GRIPPER

Tooling Modifications

Analysis and Recommendations

Illustration 1

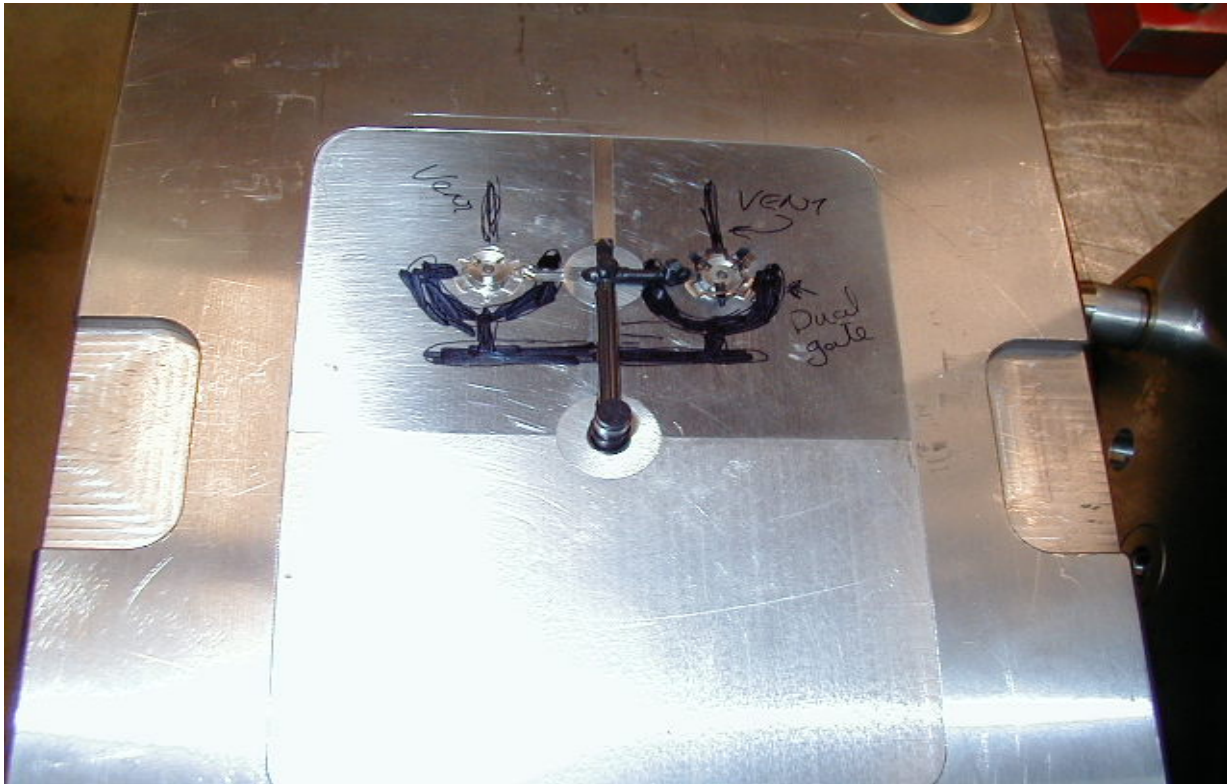
Molded parts and each major component of the mold were carefully evaluated and scrutinized. This lead to determination and conclusion that in order to mold flash free parts the tooling components must be remanufactured and match-burned or match-EDM (A technique where the steel is used as an electrode when burning mating halves together to achieve matched fit). A short shot is occurring consistently at the one of the Gripper legs situated the farthest form the gate location of the part. Material has to travel further to fill this area and it appears to be contributing to the short shot problem. Also, there are no vents at the parting line to remove the air and volatiles. A decision is made to recut the runner, add a second gate positioned 180° apart (Illustration 1) and add vents at parting line.

Illustration 2

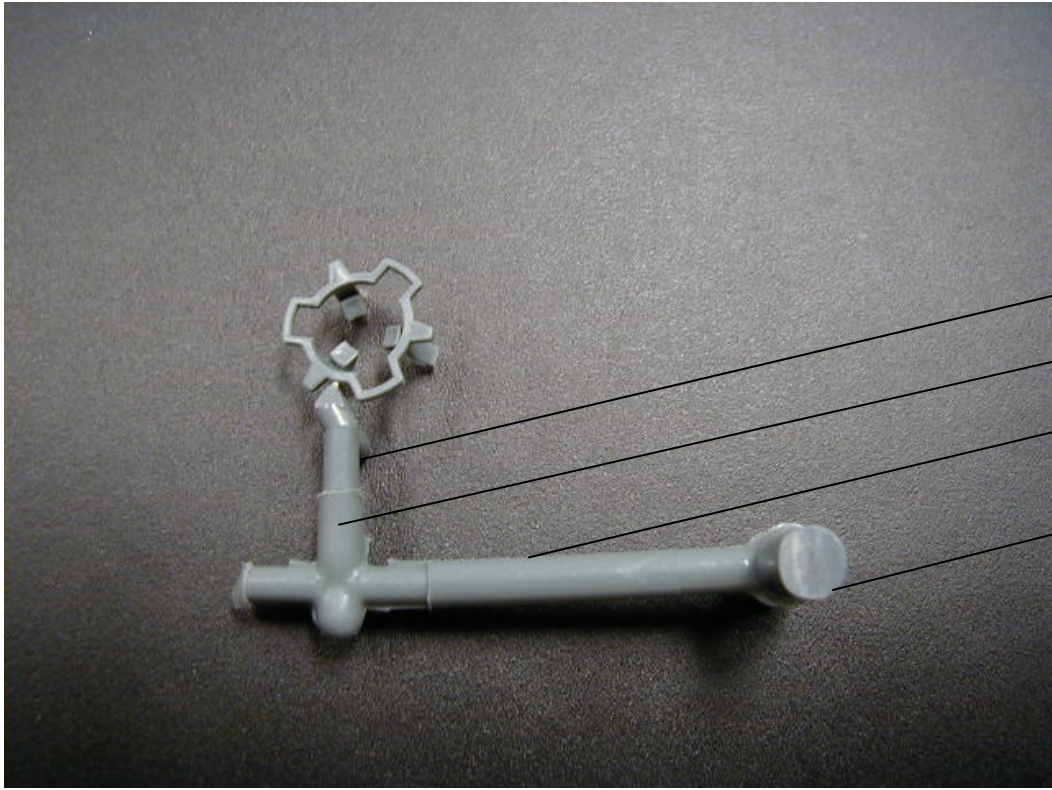
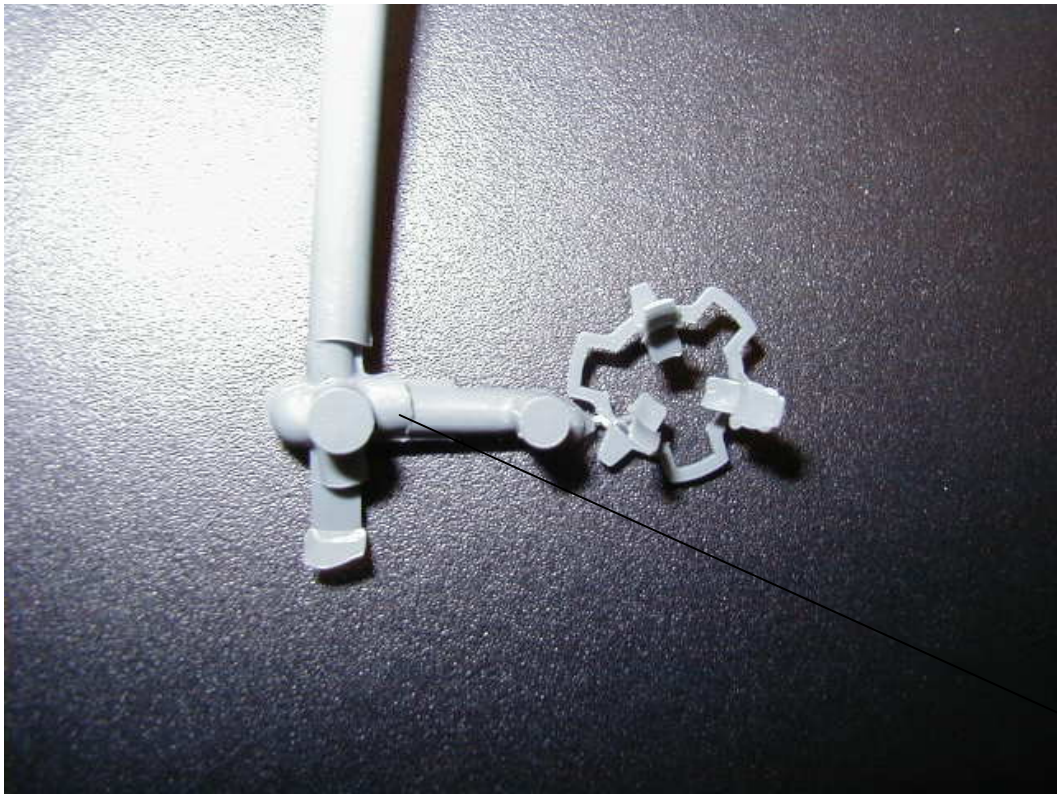
As the material flows from the sprue to the primary runner to the secondary runner and tertiary runner and so on, the pressure drops at every transition. This pressure drop also creates a drop in velocity of the material racing through the runner channels at every transition. In order to maintain constant velocity and temperatures throughout the runner system, the diameter of the secondary and subsequent runner branches are reduced. However, if the diameters of subsequent runners are reduced too much, it also creates imbalance condition. Many rules and strategy exist for runner sizing. I most often use 0.050 reductions from sprue diameter to first runner and 0.025 reductions every drop there after. In the current configuration there is also a step and a mismatch (Illustration 2), which should be eliminated.

Injection pressure required to fill this part is around 1200 psi. In order to reduce flashing and over packing and stresses that result from over packing it is desirable to reduce the pressures to the lowest level possible. Gate diameter of the current design is .015, which I believe is too small and restrictive. It is quite possible that the gate is freezing off prematurely requiring much higher pressures to fill and pack the parts. I recommend opening up the gate to .029 (width and depth) to improve flow.

Mismatch

Current	Proposed
Sprue Diameter	.250	.250
Primary Runner Diameter	.156	.200
Secondary Runner Diameter	.140	.175
Step	.125	No Step
Gate size (Width & depth)	.015 X .025	.029 X .029
Gate	Single	Dual
Vent @ P/L	None	Add

Moldflow Analysis Results (Single gate vs. Two gates)

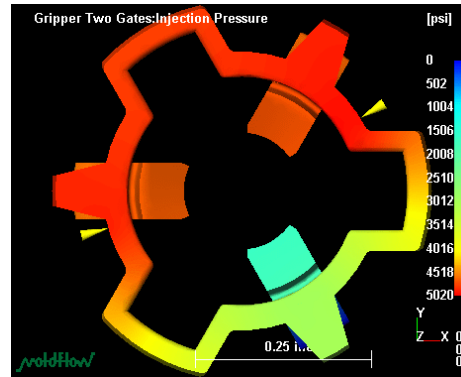
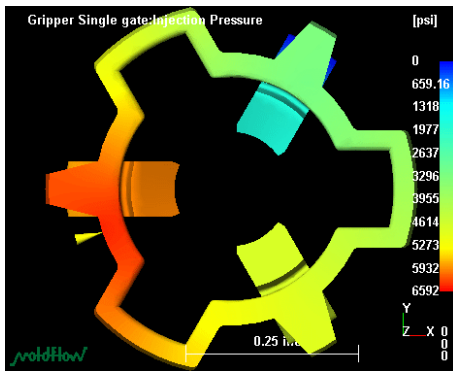
Injection Pressure reduced by 1500 psi

Faster fill in critical area

Fill pattern changed

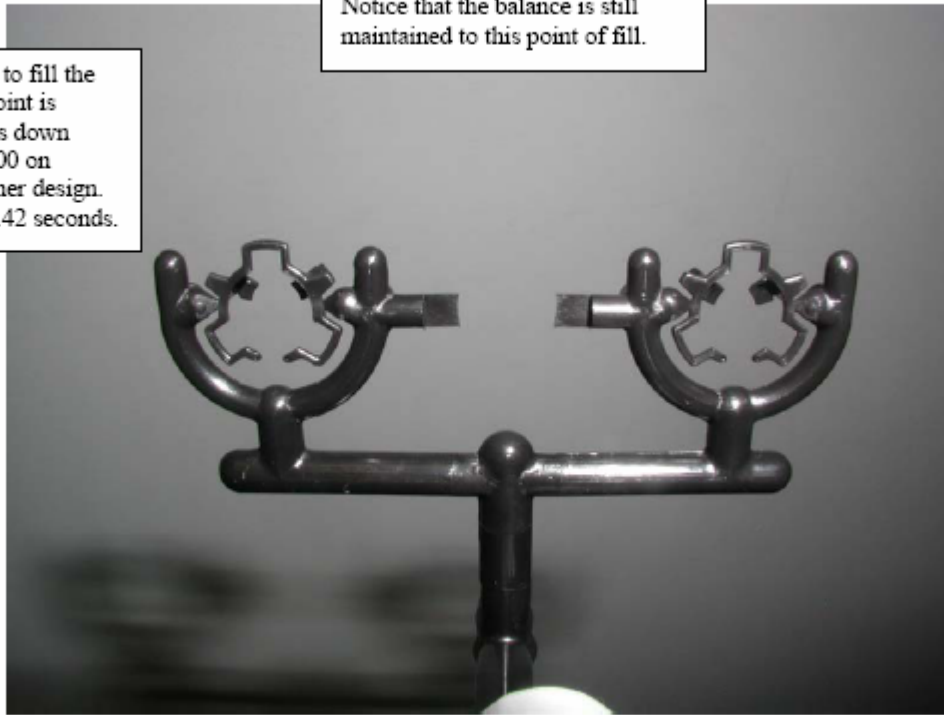
Notice that the balance is still maintained to this point of fill.

The pressure to fill the part to this point is 640psi; this is down from 900-1000 on previous runner design. Fill time is 0.42 seconds.

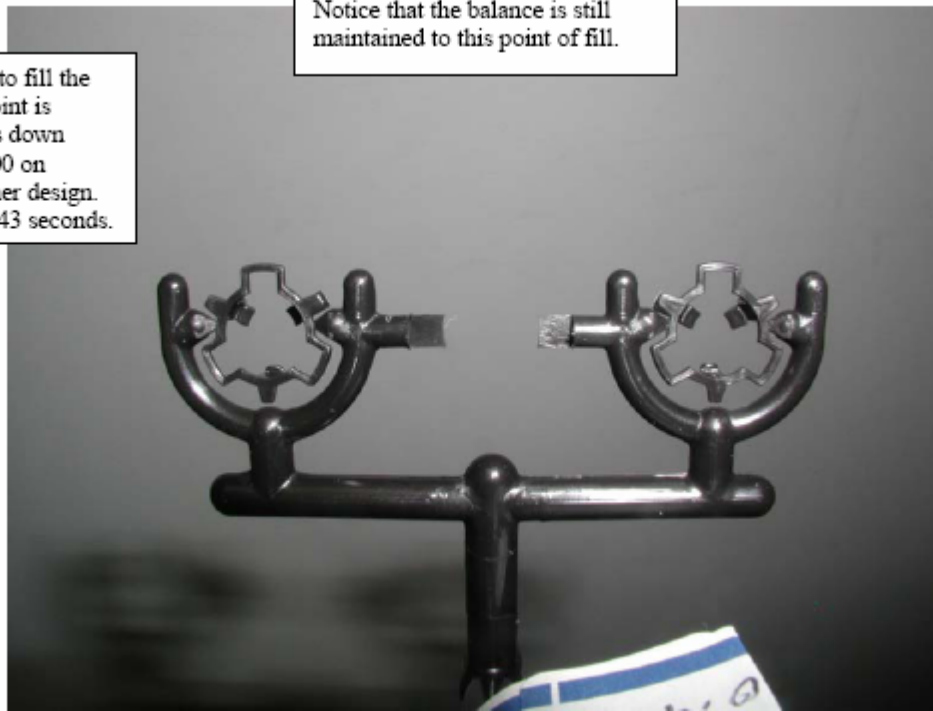
Notice that the balance is still maintained to this point of fill.

The pressure to fill the part to this point is 645psi; this is down from 900-1000 on previous runner design. Fill time is 0.43 seconds.

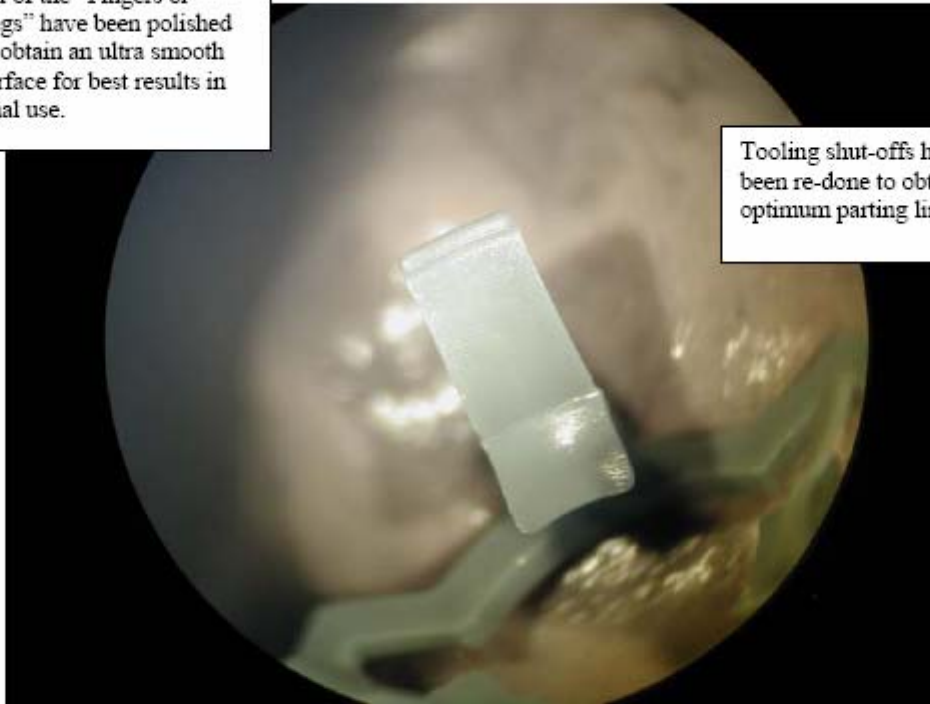
All of the "Fingers or Legs" have been polished to obtain an ultra smooth surface for best results in final use.

Tooling shut-offs have been re-done to obtain optimum parting lines
